Access Compliance Report

Public Rights-of-Way

Intersection ID: 52336	Main Street: WOODWARD_AV	Cross Street: KOHLER_AV	Location:	N
ADA ID: B4B86DD129AC	Ramp Type: BlendTrans1	Initial Pass/Fail: Pass	Overall Compliance: No	Severity Score: 7.5

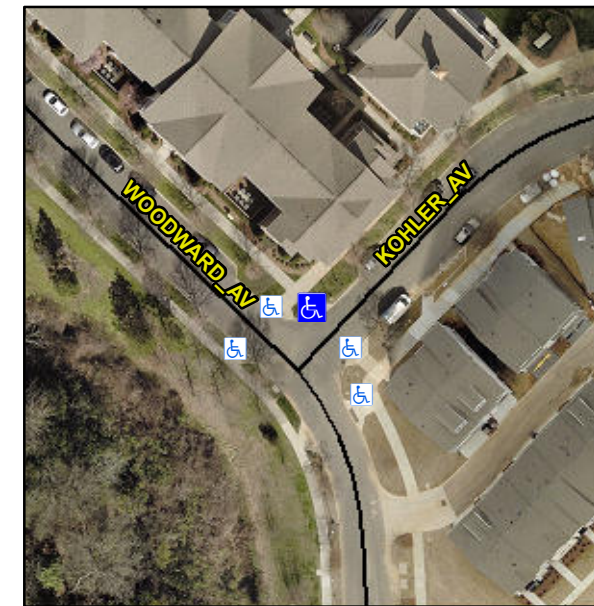
Not Found, R305.1.4, R305.2, R302.7, R302.7.2, R304.5.3

Compliance	Description	Data	Compliance	Description	Data
N/A	Ramp Length (in)	138.0	Yes	BlendTrans Slope (%)	4.4
Yes	Ramp Width (in)	71.0	Yes	BlendTrans XSlope (%)	2.0
N/A	Flare Type LT	Sloped	N/A	Flare Type RT	Sloped
N/A	Flare Slope LT (%)	11.1	N/A	Flare Slope RT (%)	0.8
N/A	Flare Traversable LT?	No	N/A	Flare Traversable RT?	No
Yes	Landing Length (in)	96.5	Yes	DWS Provided?	Yes
Yes	Landing Width (in)	71.0	Yes	DWS Contrast?	Yes
Yes	Landing Slope (%)	1.2	No	DWS Length (in)	23.5
Yes	Landing X Slope (%)	1.7	Yes	DWS Full Width?	Yes
N/A	Landing Curb? (Y/N)	No	No	DWS Offset (in)	4.0
N/A	Shared Landing?	No			
No	Gutter Ponding?	Yes	Yes	Gutter Slope (%)	1.1
No	Gutter Lip Ht (in)	0.5	No	Gutter X Slope (%)	3.8
N/A	Painted X Walk1?	No	N/A	Painted X Walk2?	N/A
	X Walk 1 Direction	To SE		X Walk 2 Direction	N/A
	X Walk 1 Width (in)	N/A		X Walk 2 Width (in)	N/A
	X Walk 1 Slope (%)	1.1		X Walk 2 Slope (%)	N/A
	X Walk 1 X Slope (%)	2.7		X Walk 2 X Slope (%)	N/A

N/A	Ramp inside XWalk1?	N/A	N/A	Ramp inside XWalk2?	N/A
	Road Slope (%)	2.7		Clear Space?	Yes
	Road X Slope (%)	1.1	N/A	Clear Space to XWalk (in)	N/A
Yes	Any Obstructions?	No	Yes	Storm Grate/Utility Hazard?	No
	Obstruction Type			Storm Grate/Utility Type	
			N/A		N/A
			Yes	Surface Condition? (G/P)	Good
			No	Curb Slope (%)	20.5

Remove & Replace Curb Ramp With Two New Directional Ramps or Equivalent. Remove & Replace Gutter.
